Subject: Duke Energy Carolinas, LLC
William States Lee III Nuclear Station - Docket Nos. 52-018 and 52-019
AP1000 Combined License Application for the
William States Lee III Nuclear Station Units 1 and 2
Transmittal of Unit 1 Foundation Input Response Spectra (FIRS)
Horizontal and Vertical Component Analysis
Ltr# WLG2010.02-01

- 1) Summary of Changes to FIRS A1 Analysis and Associated FSAR Revisions
- 2) Development of Horizontal and Vertical Site-Specific Hazard Consistent Uniform Hazard Response Spectra at Lee Nuclear Station Unit 1, Revision 3

Summary of Changes to FIRS A1 Analysis and Associated FSAR Revisions

**Revised FSAR Figures 2.5.2-240, 2.5.2-241, 2.5.2-244, 2.5.2-245, 2.5.2-246,
2.5.2-247, 3.7-201, and 3.7-202**

FIGURE 2.5.2-240

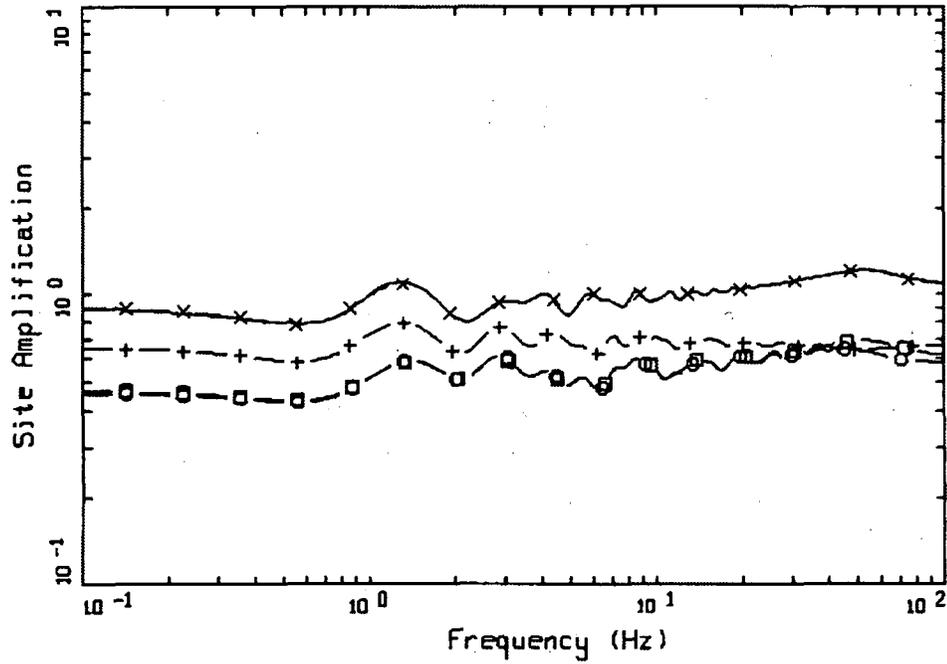
For Lee Nuclear Station Unit 1 FIRS the site-specific V/H ratios, Figure 2.5.2-240 shows median estimates computed with the stochastic model for M 5.1. For M 5.1, the distances range from 50 to 0 mi. (80 to 0 km) (Table 2.5.2-221) with expected horizontal hard rock peak accelerations ranging from 0.01 to 0.50g. Figure 2.5.2-240 shows that the V/H for the shallow concrete profile Unit 1 FIRS are nearly constant with frequency and increase rapidly as distance decreases, within about a 9 mi. source distance. For distances beyond 6 to 9 mi., the V/H ratio is about 0.5 and increases rapidly to about 0.9. The peak near 60 Hz is likely due to the peak in the horizontal amplification factors (Figure 2.5.2-241). In Figure 2.5.2-240, the multiple peaks beginning near 1 Hz reflect deep crustal resonances (structure below 0.5 mi., Table 2.5.2-221) that would be smoothed if the crustal model were randomized and discrete layers replaced with steep velocity gradients to reflect lateral variability and a more realistic crustal structure. The M 5.1 distance ranges more than adequately accommodate the hazard deaggregation (Subsection 2.5.2.4.5).

FIGURE 2.5.2-245

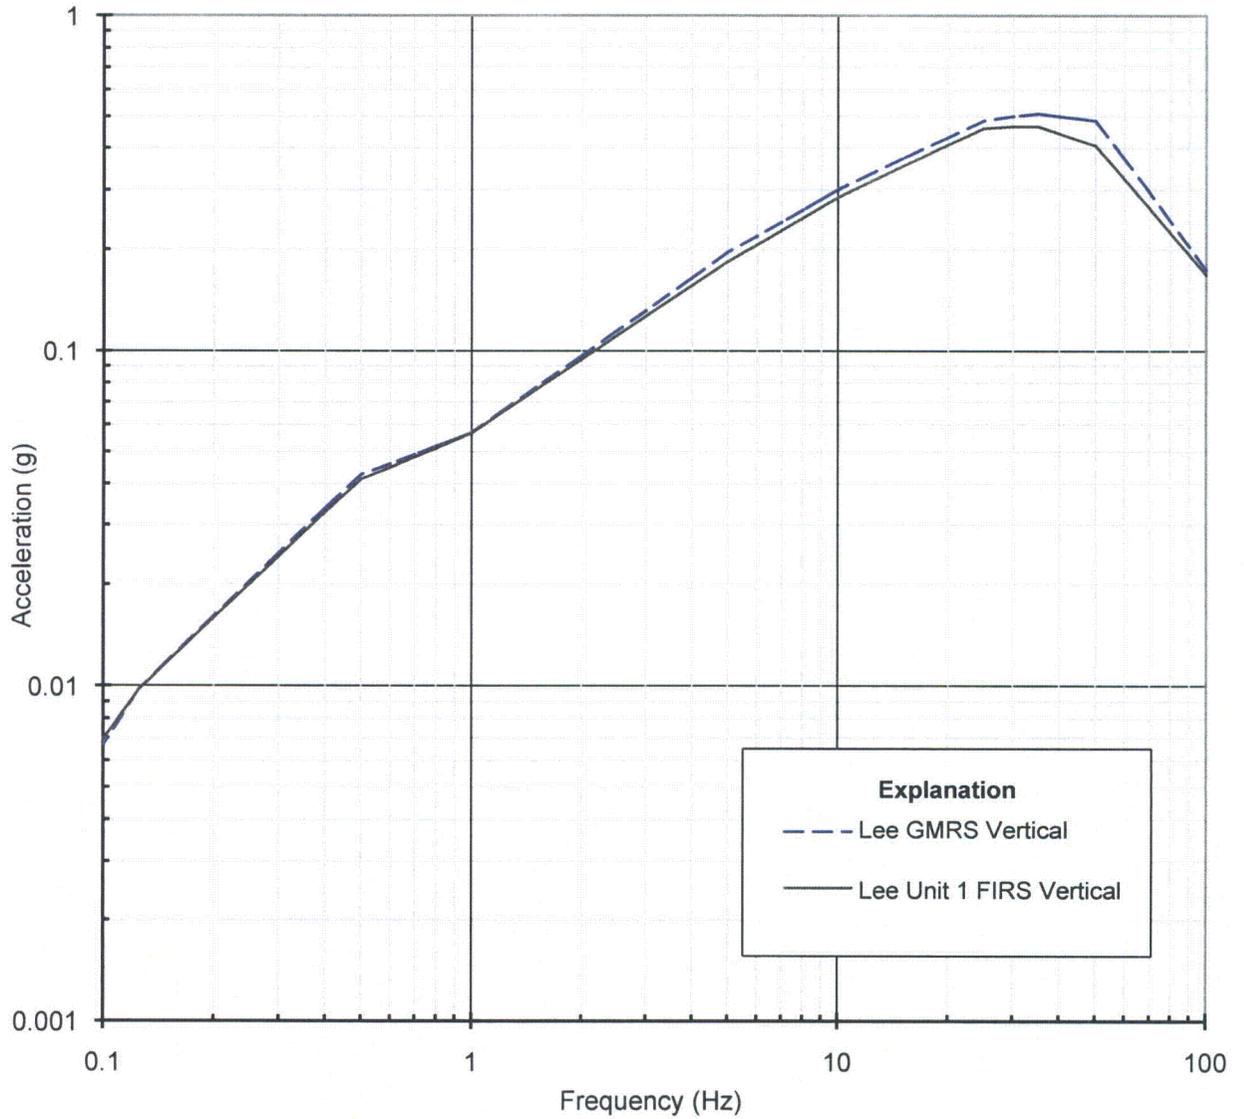
Table 2.5.2-224 and Figures 2.5.2-244 and 245 show horizontal and vertical Unit 1 FIRS developed compared to the horizontal and vertical GMRS developed for Unit 2. Figure 2.5.2-246 shows both the horizontal and vertical FIRS. Figure 2.5.2-247 shows the horizontal and vertical UHRS at exceedence levels of 10^{-4} , 10^{-5} , and 10^{-6} yr⁻¹. Through Approach 3, both the horizontal and vertical UHRS and Unit 1 FIRS are hazard- and performance-based consistent across structural frequency from 0.5 to 100 Hz, the frequency range over which the hard rock hazard is computed (Reference 273). For frequencies below 0.5 to 0.1 Hz, the extrapolation employed is intended to reflect conservatism, likely resulting in motions of lower probability. Table 2.5.2-224 lists discrete values for FIRS and UHRS horizontal and vertical spectral acceleration values for Unit 1. Section 3.7 compares the site-specific ground motions to the AP-1000 design ground motions.

FIGURE 3.7-201 Rev

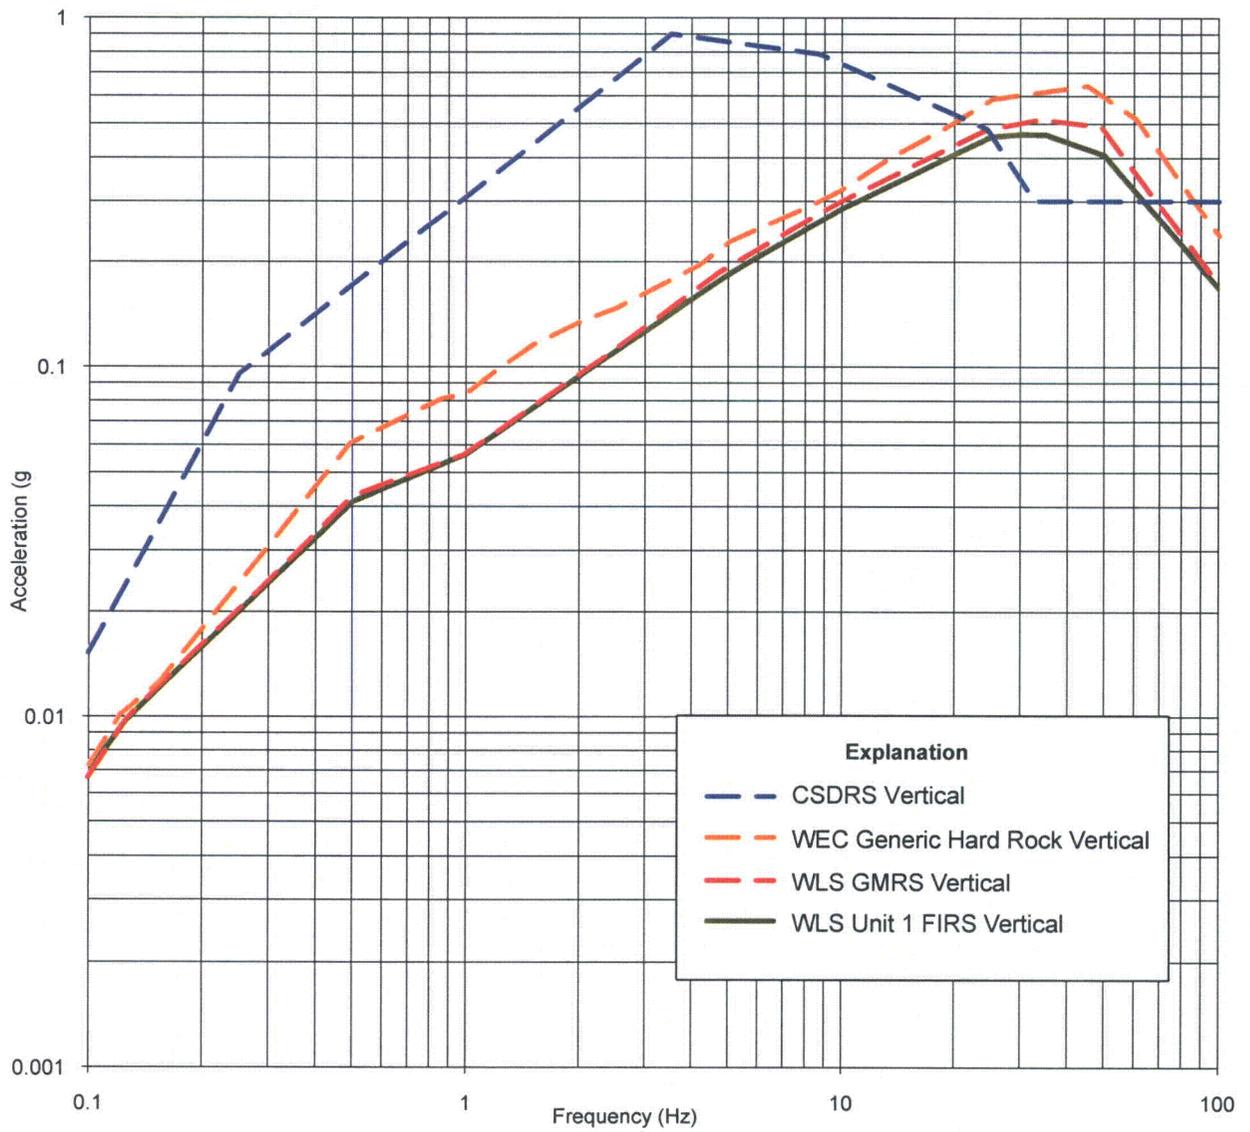
As shown on Figure 3.7-201, the horizontal GMRS and Unit 1 FIRS exceed the horizontal CSDRS at frequencies of about 20 to 75 hertz and 20 to 85 hertz, respectively. PGA at 100 hertz of the GMRS and Unit 1 FIRS is 0.21 g and ~~0.24~~0.22 g, respectively. As shown on Figure 3.7-202, the vertical GMRS and Unit 1 FIRS exceed the vertical CSDRS at frequencies between about 25 to 70 hertz.
